International Panel of Experts

Safety of Nenskra Hydropower Project - Georgia

STAGE II REPORT - Part 2 & Final

Date: 27 February 2017

Figure 1 Soil Strata - Cross section at the valley floor

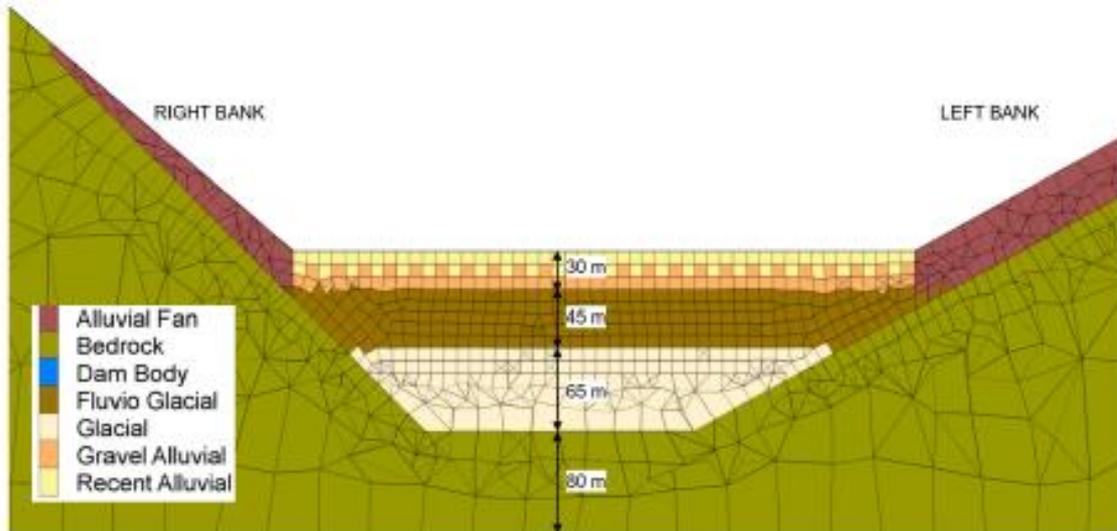
In the Stage II - Part 1 report the IPOE recommended that the EPC Contractor drill complementary investigation boreholes in the foundations of the right abutment to confirm a conservative geological model has been used in the analysis. We understand that BH-R-150-2 is being drilled in the right abutment; it has reached about 80m depth and is yet to confirm the depth to the bedrock.

Figure 4 Seepage Sensitivity Results

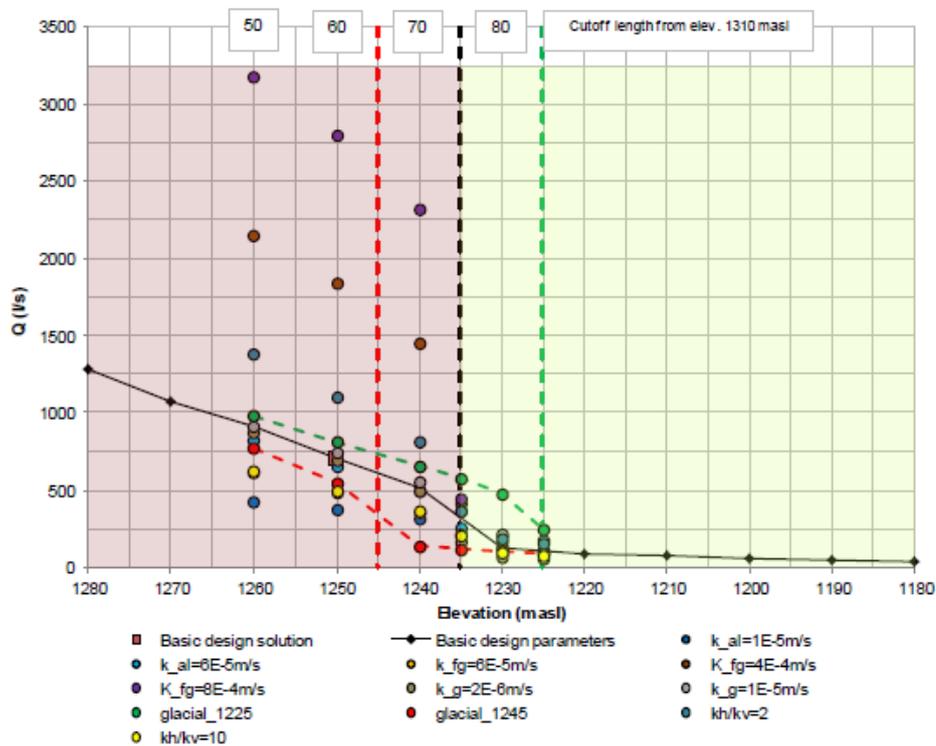
Results of the seepage sensitivity analysis are presented in Figure 4 below. It can be seen that for an 85m deep cut-off wall a seepage of 170 l/s is expected, which is acceptable and is within the specified requirements.

The analysis has also shown that the maximum water table rise in the embankment would be 4m, which justifies a 5m thick drainage layer within the footprint of the embankment in the valley sections.

Figure 5 Hydraulic Gradient at the valley floor (cut-off wall depth at 1225masl)

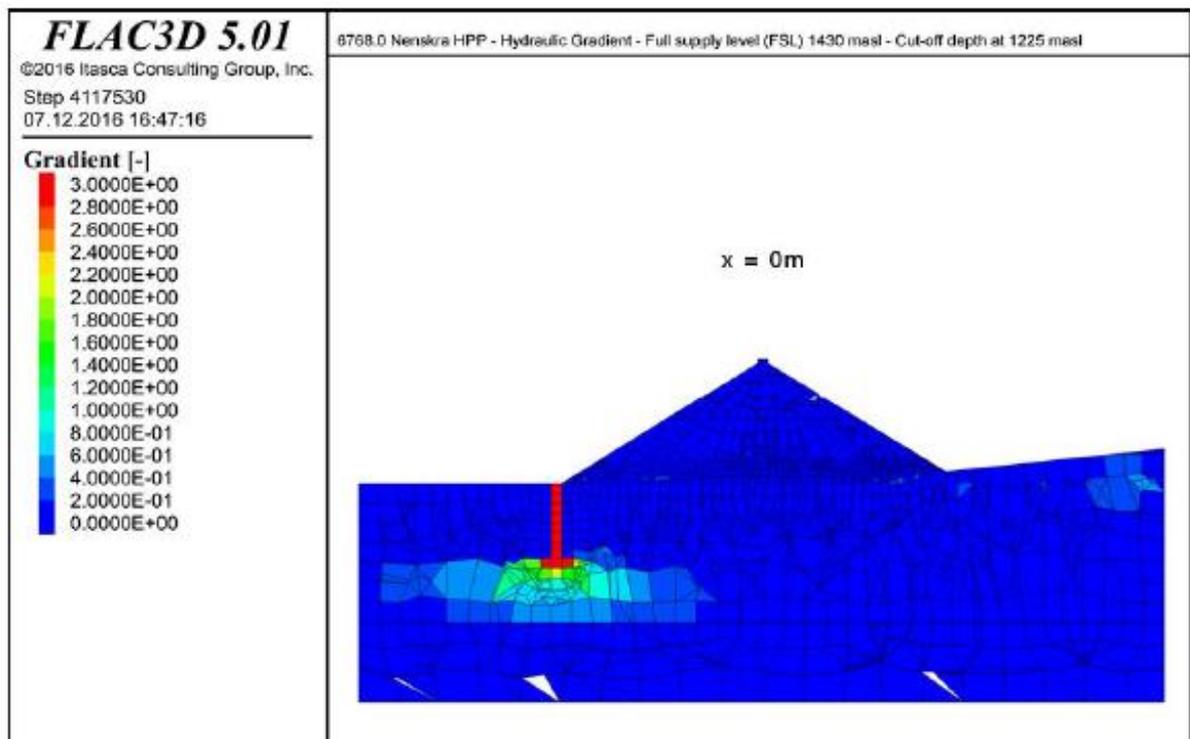
The analysis has shown that the high gradients identified at the bottom of the cut-off wall are unlikely to lead to suffusion, due to confinement of the particles. Some local migration of particles might occur, but a presence of a thick filter layer, that would be placed between the foundation soil and the 3A embankment fill, over 80m length, should mitigate the risk that might be caused from the upwards movement of soil particles. The IPOE agrees with the analysis and conclusions.

Figure 7 Location of Lacustrine Deposits

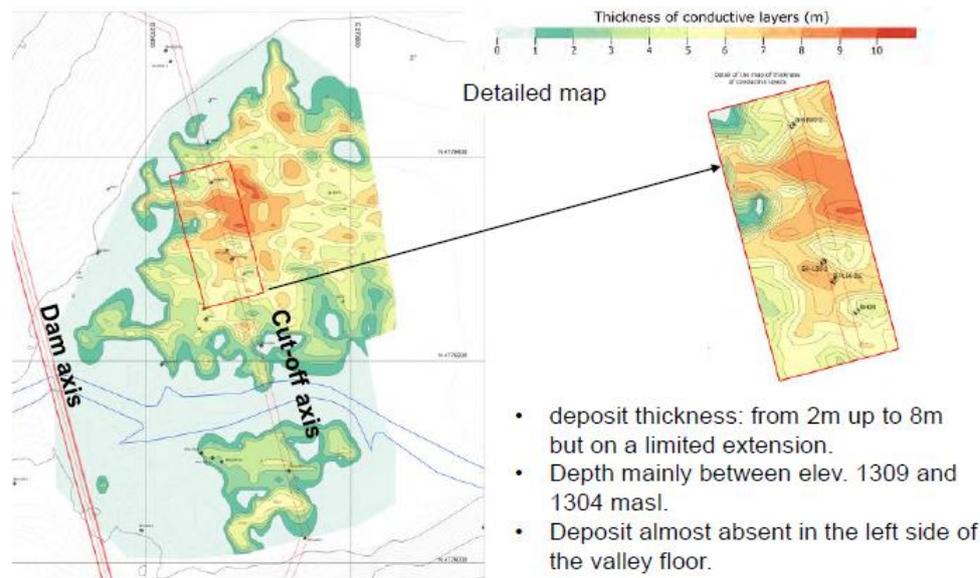
The design documents submitted in December 2016 show that soft lacustrine deposits, up to 10m thick, have recently been encountered in the valley floor, below the Zone 3A of the upstream embankment shoulder (see Figure 7 below). The artesian ground water table encountered in the deposits is +0.5m to –1m below the ground level.

These soft deposits were originally envisaged to be either excavated and replaced or treated in-situ. Since the ground water level is high, it is most likely that the deposits will not be excavated, but treated in-situ.

Figure 8 Crest Detail

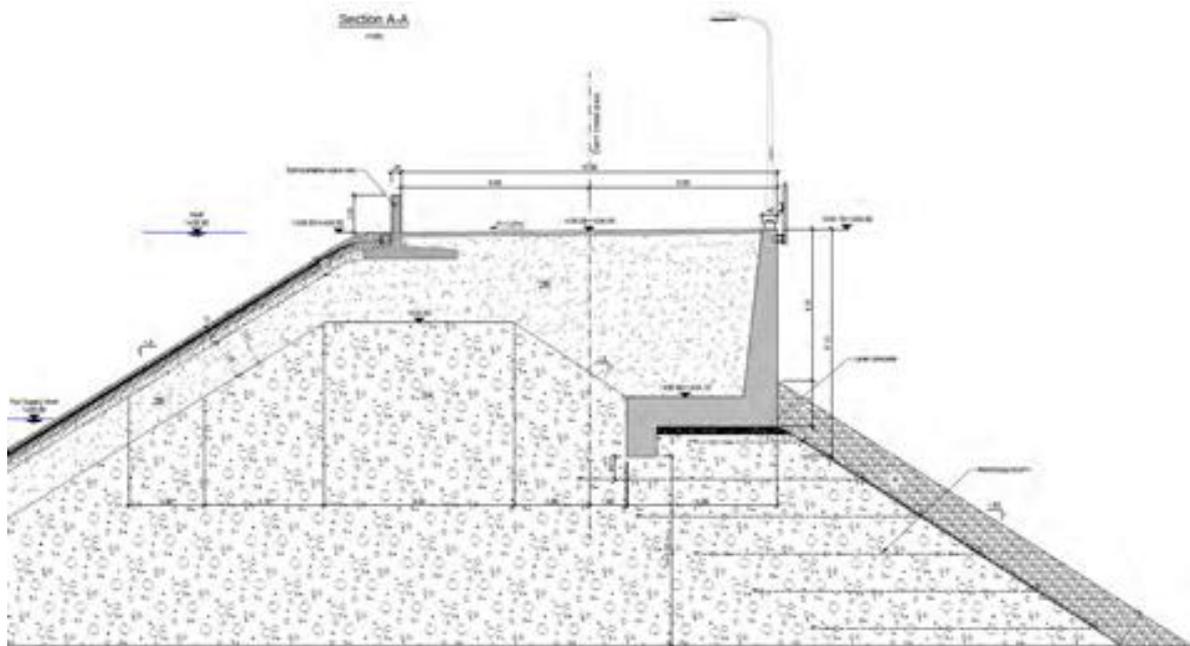
As shown on Figure 8 below, the final Basic Design now includes a 6m high wall constructed at the downstream side of the crest and a 1m high upstream parapet wall.

With the parapet wall added to the Dam crest, the freeboard added to the FSL is 6m and to the design flood at 1433masl is 3m. The freeboard will be sufficient to accommodate combined flood inflows and wind wave action as well as potential waves triggered by debris flows.

Figure 9 Height of AFRD and Thickness of Asphalt Face

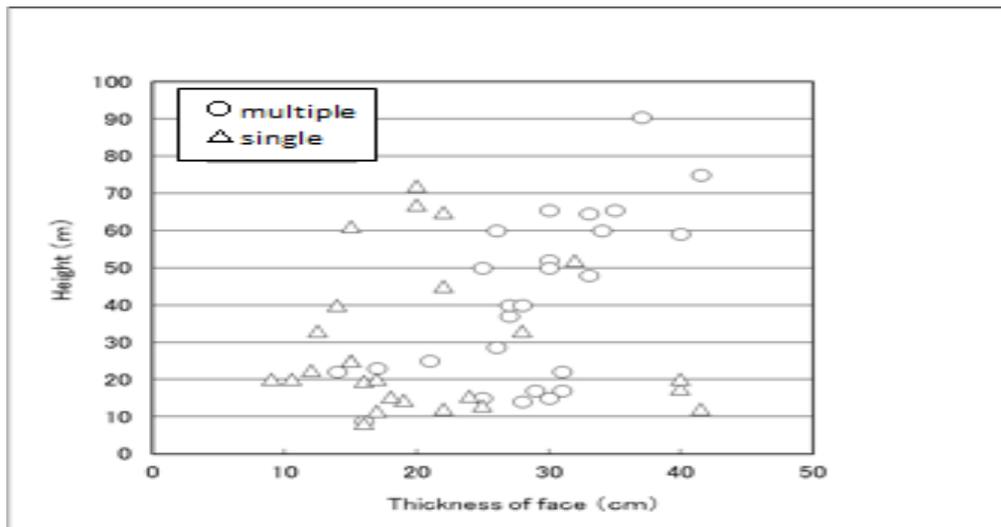
As previously noted by the IPOE, Nenskra Dam is a very high AFRD, it will be subjected to large hydrostatic pressure and further consideration needs to be given to the appropriate thickness of the face. From past records of dam construction it can be noted that the thickness of the asphalt face increased as the height of the dam as well as the maximum water pressure. However, the thickness of the proposed Basic Design is uniformly 31 cm. Figure 9 below shows the thickness of the asphalt face vs the height of the current AFRDs.

The IPOE recommends that further consideration be given to the appropriate thickness of the asphalt face, which shall be determined by taking into consideration properties obtained from laboratory and field tests and the required performance.

Figure 10 Zanger’s Formula

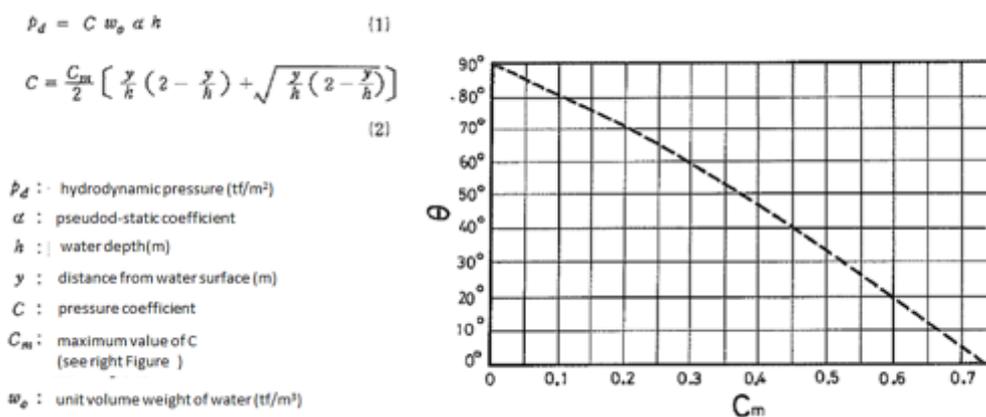
In the current analysis conducted by the EPC Designer, the hydrodynamic effect caused by an earthquake is not considered. There is, however, a probability of larger strain of the asphalt face under the water affected by the hydrodynamic pressure. Thus, the IPOE recommends checking this effect by using added mass as the hydrodynamic pressure, if possible. The added mass can be calculated, for example, by Zanger’s formula, as shown in Figure 10 below.

- f. To check the effect of the hydrodynamic pressure on the seismic analysis by using added mass, if possible.

Figure 12 Polymer modified asphalt

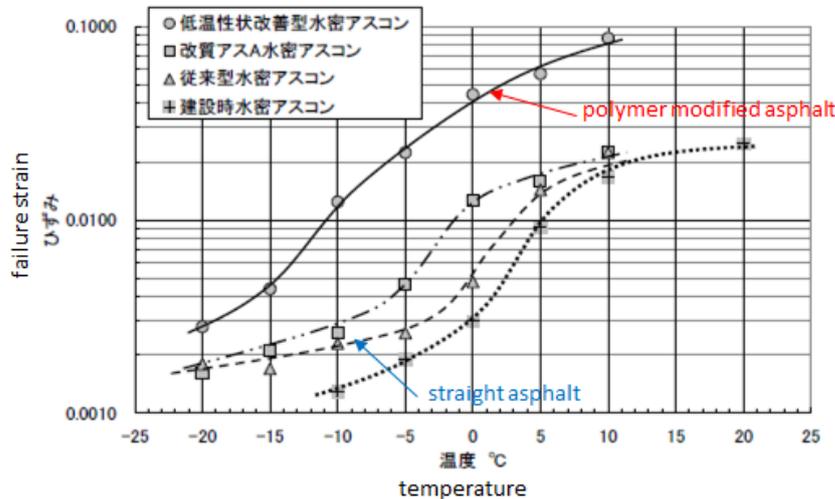
In consideration of the conditions mentioned above, it seems difficult to ensure the allowable maximum strain of 1% at -5 °C and 2% at 0 °C while using the same material as these dams. Therefore, it may be necessary to use special material such as polymer modified asphalt that was developed for the purpose of improving deformation performance under low temperatures. This material also has sufficient resistance against flow under high temperatures. The slope flow value of fine-grained asphalt concrete using this material was about one third of straight asphalt¹. Also, this material had

about three times larger failure strain than that of fine grained asphalt concrete using straight asphalt as shown in Figure 12 below. Follow-up surveys were conducted around five years after the repair works of an asphalt faced earth dam damaged by cracking in East-Yamanashi earthquake (M5.8) in Japan. The results revealed that repaired asphalt concrete had remained in a satisfactory condition without any sign of deterioration by ageing.²

- g. To examine temperature, strain rate and failure strain of asphalt concrete, since it seems difficult to ensure the allowable maximum strain as proposed by the EPC Designer. Therefore, it may be necessary to use special material such as polymer modified asphalt.

Figure 14 Basic Design - Gallery – Asphalt Face Connection Detail

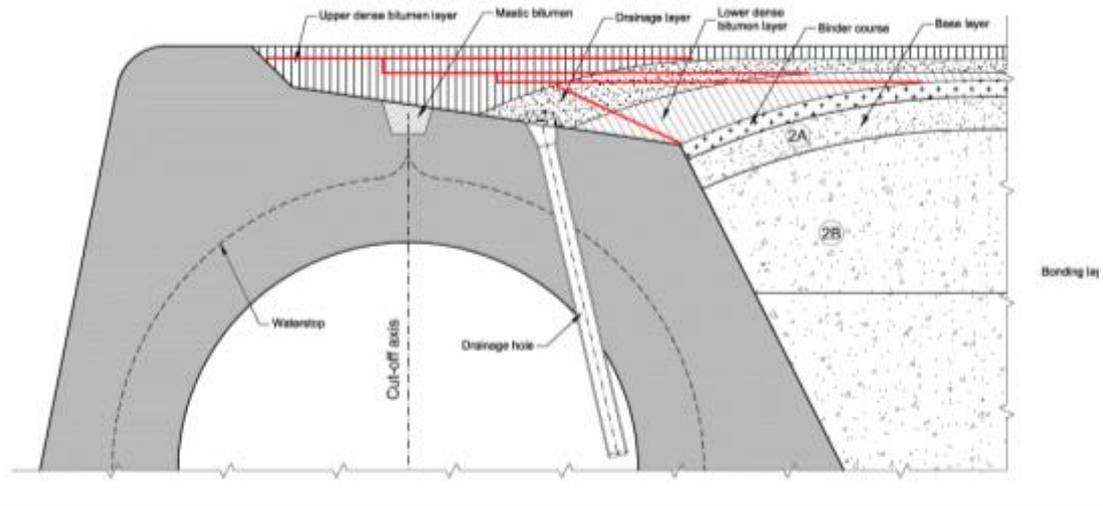
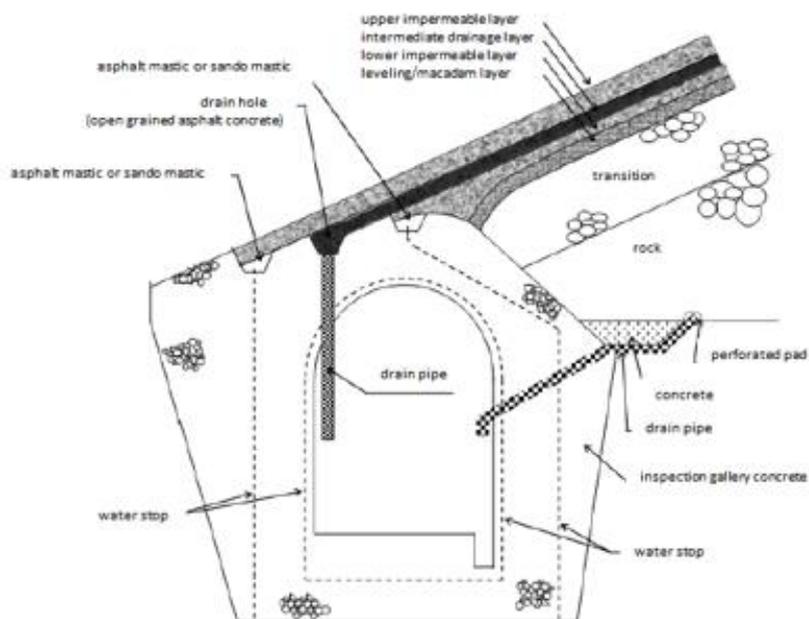
Even though the IPOE understands the EPC Designer's intention, the IPOE has a concern that it may be difficult to construct the paving of the curved asphalt face as designed using an asphalt finisher. Thus, the IPOE recommends that the EPC Designer study the possibility of application of the shape of the connection part as shown in Figure 15 below.

Regarding design of the joint part of the asphalt face and inspection gallery concrete, it seems difficult to pave the layers with asphalt finishers, since the thickness of each layer of the asphalt face is changing from place to place as shown in Figure 14. Therefore, the IPOE recommends that the connection part of the asphalt face with the gallery be designed as shown in Figure 15. The top of the gallery concrete should be a stepped shape, like stairs, so that the thickness of each layer can be uniform and straight. Paving work will be easier with asphalt finishers and achieve a higher quality result. The red lines in Figure 14 indicate an example of the modified shape of the top of the inspection gallery concrete and each layer of asphalt face.

Figure 16 Asphalt Face at the Dam Crest

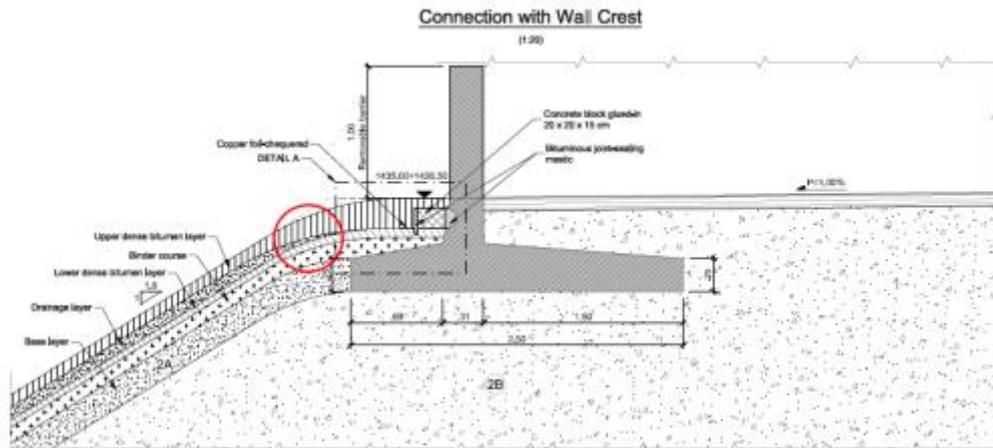
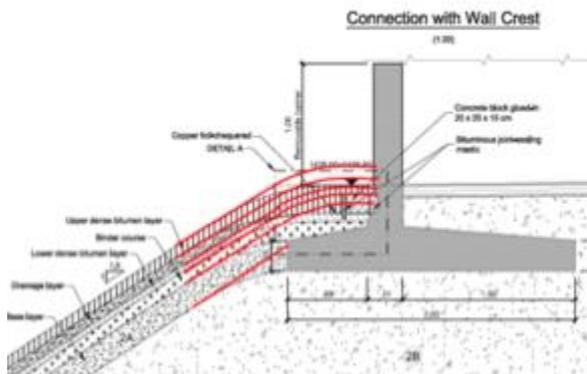
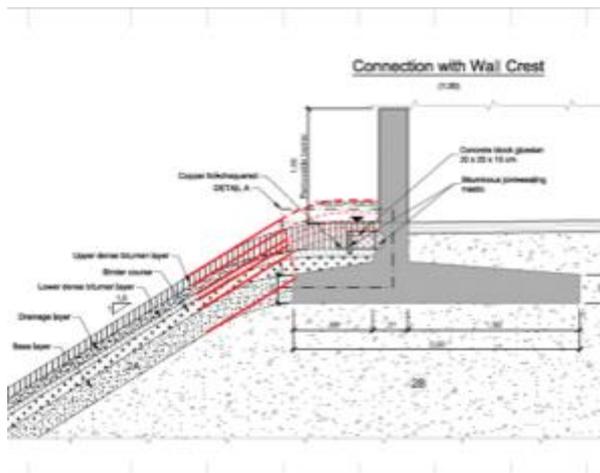
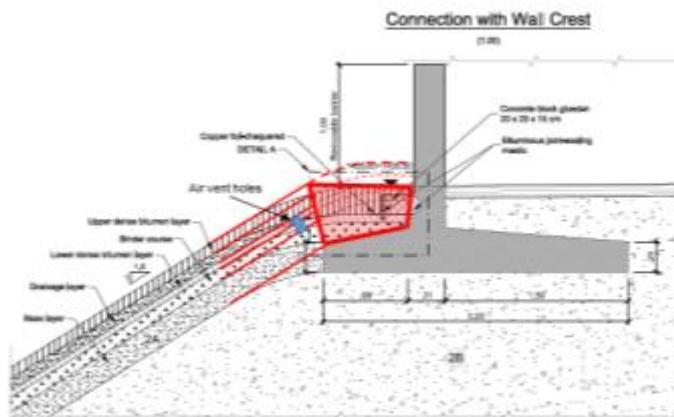
It seems difficult to pave the intermediate drainage layer near the crest, since it is gradually thinning as shown in Figure 16 below. The IPOE recommends that the shape of this part be modified in consideration of the construction stage.

While an example of the face structure construction is shown below, it should be considered very carefully in order to alleviate the concentration of strain. The red lines indicate a potential modified shape of each layer of asphalt face and filler.

The IPOE therefore recommends modifying the design of the face structure near the crest concrete in order to provide a larger flexibility against the displacement of the crest concrete during an earthquake.

- o. To install air vent pipes above FSL at regular intervals over the full length of the dam crest for smooth drainage of leakage water. The position and direction of the air vent pipes is recommended as shown in Figure 19.

Figure. 20 Leakage measurement equipment in the inspection gallery

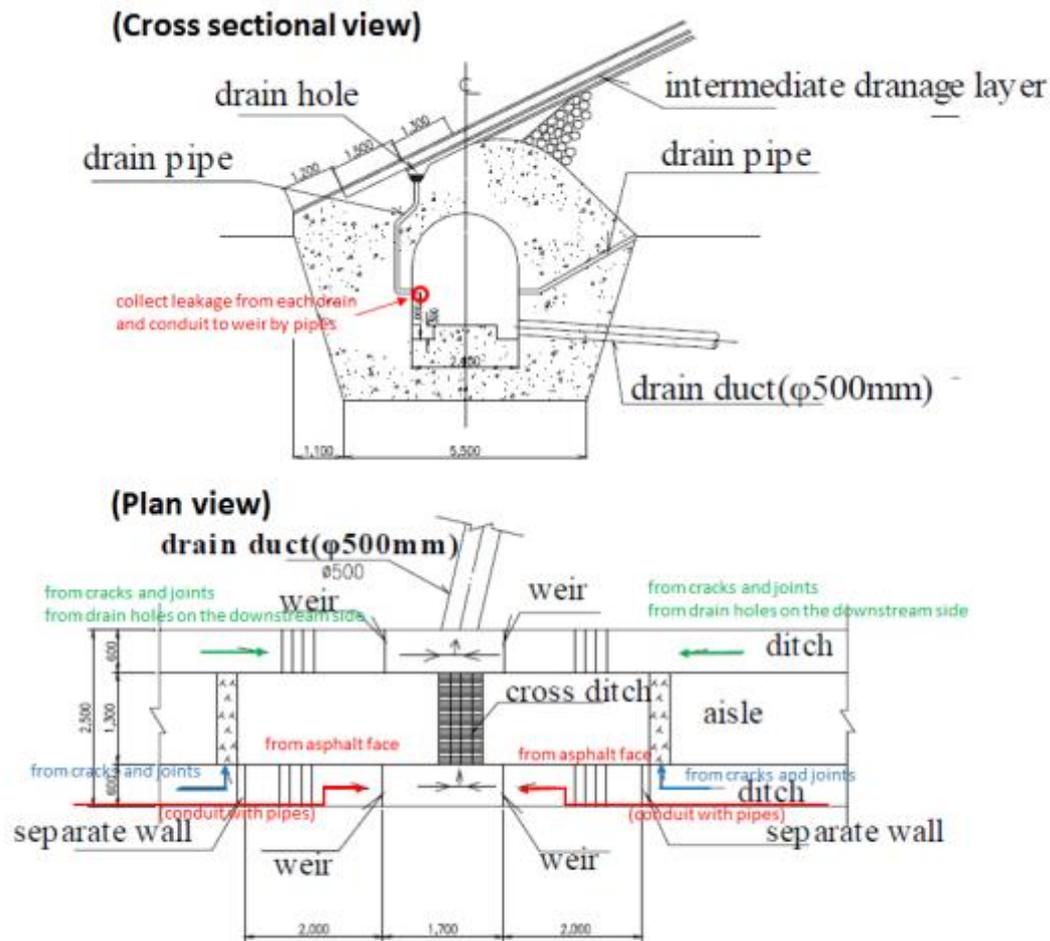
- 1) Facilities for leakage water measurement include:
 - a. Drainage channels on both sides of upstream and downstream in the gallery are installed as shown in Figure 20.

Figure 21 Downstream zone of the Bottom Outlet and Spillway Tunnel

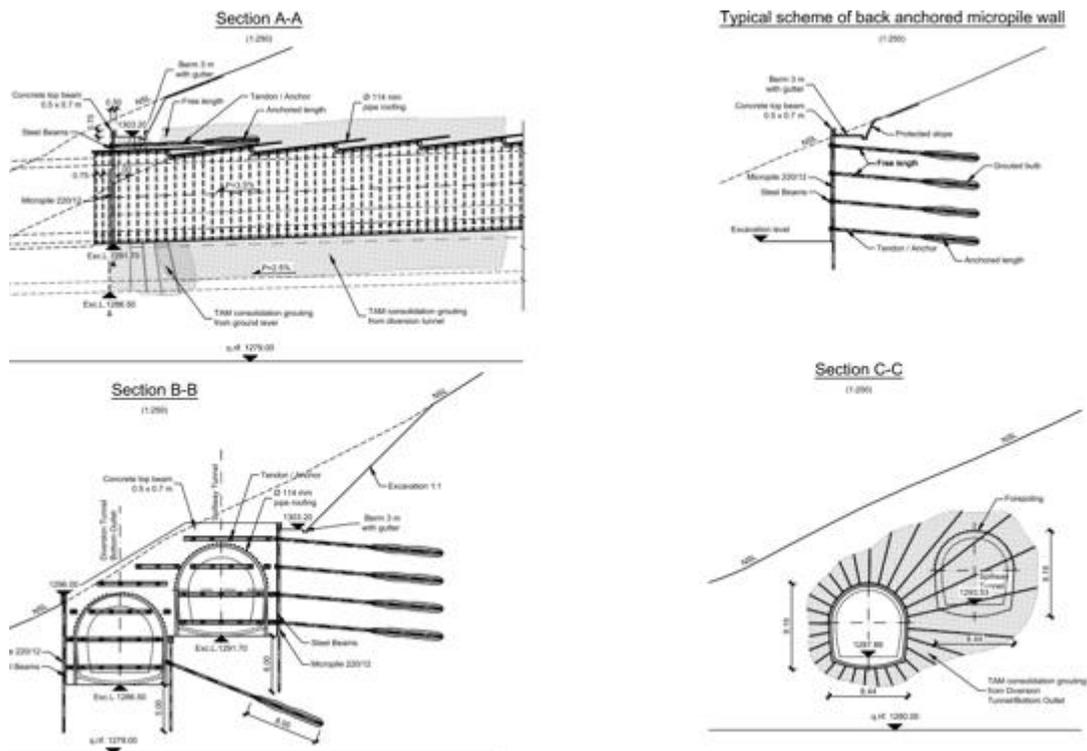
As noted above the value of having a Bottom Outlet tunnel independent from the Spillway tunnel is a critical safety measure at Nenskra. It is important therefore for the two tunnels to be as independent from one another as practicable. The IPOE is concerned that the current arrangement of the two tunnels coming in close proximity at the downstream sections (Figure 21) limits this independence. Since the downstream sections are to be constructed in loose material should local movement arise due to earthquake or settlement then both tunnels are likely to be simultaneously affected. If the outlets of the two tunnels are separated this risk is reduced. Therefore the IPOE suggests further consideration of the alignment of the Spillway tunnel. This is discussed further at section 3.6.3.
